NORTH ANNA POWER STATION, UNIT NO. 1

Amendment No. 22  
License No. NPF-4

AMENDMENT NO. 22 TO FACILITY OPERATING LICENSE NO. NPF-4

RELATED TO AMENDMENT NO. 22 TO FACILITY OPERATING LICENSE NO. NPF-4

FIGURE 3.2-1. AXIAL FLUX DIFFERENCE LIMITS AS A FUNCTION OF RATED THERMAL POWER

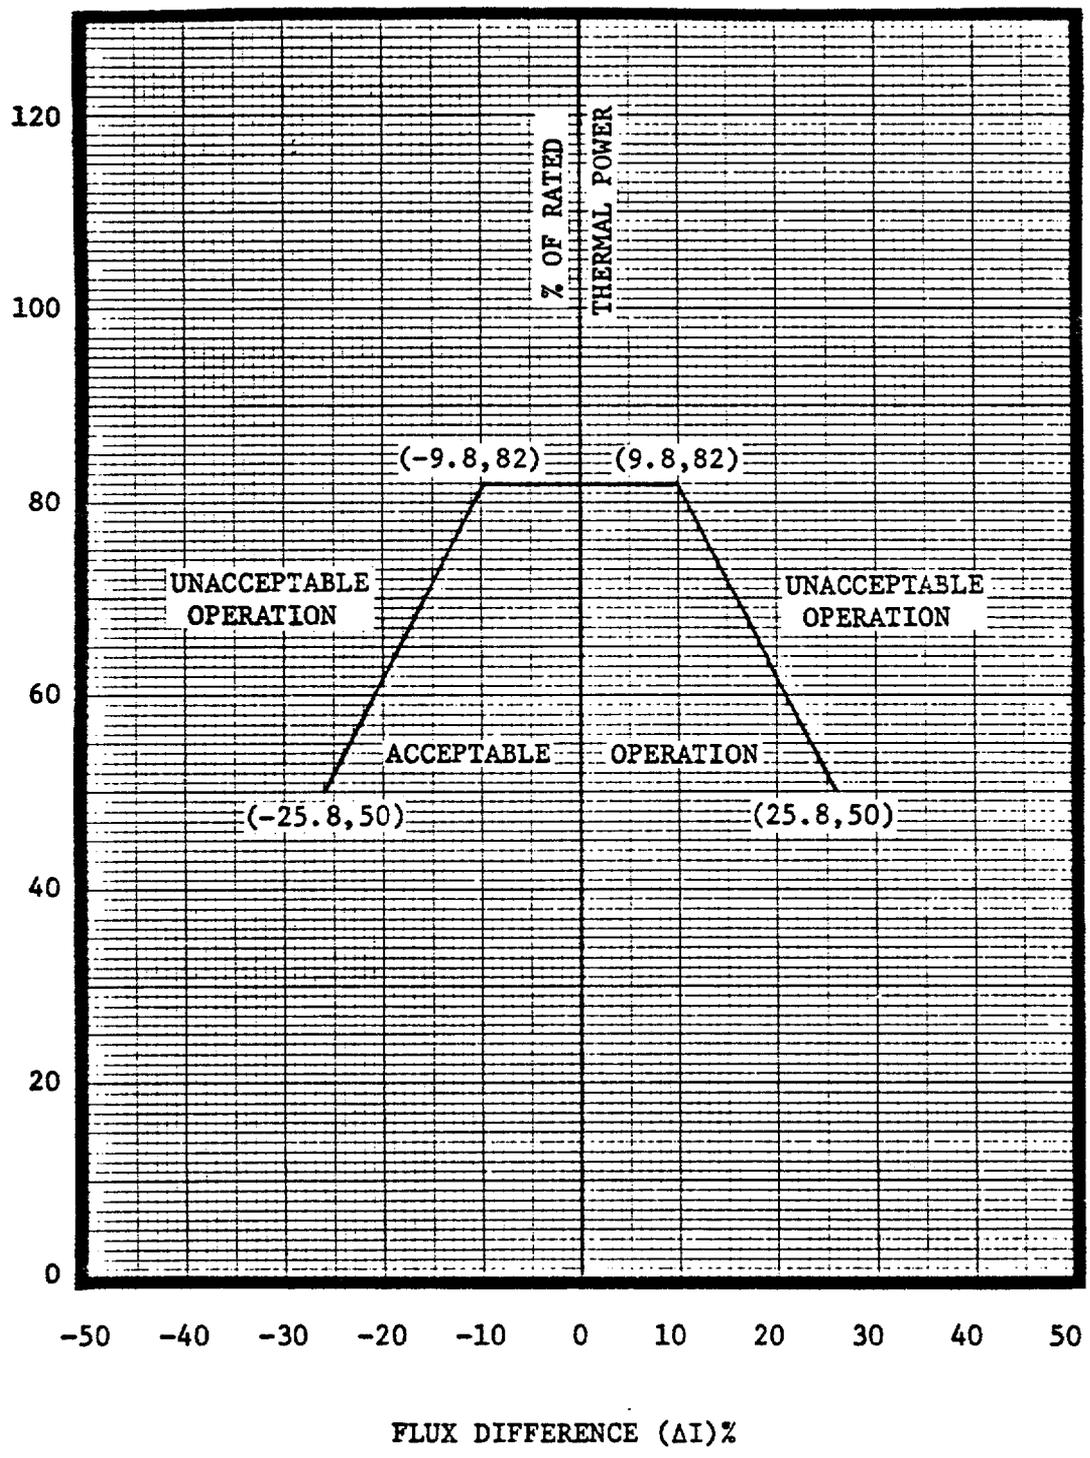
The amendment makes changes in the axial power distribution surveillance turn on power and part power axial flux difference limits. These changes ensure that the total peaking factor as a function of core height limits currently specified for NA-1 will continue to be met for the remainder of Cycle 2 and and forthcoming Cycle 3 operations.

- 2) The indicated AFD is within the limits shown on Figure 3.2-1. Otherwise, reduce THERMAL POWER to less than 50% of RATED THERMAL POWER within 30 minutes and reduce the Power Range Neutron Flux-High Trip Setpoints to  $\leq 55\%$  of RATED THERMAL POWER within the next 4 hours.

- b) Surveillance testing of the Power Range Neutron Flux Channels may be performed pursuant to Specification 4.3.1.1.1 provided the indicated AFD is maintained within the limits of Figure 3.2-1. A total of 16 hours of operation may be accumulated with the AFD outside of the target band during this testing without penalty deviation.
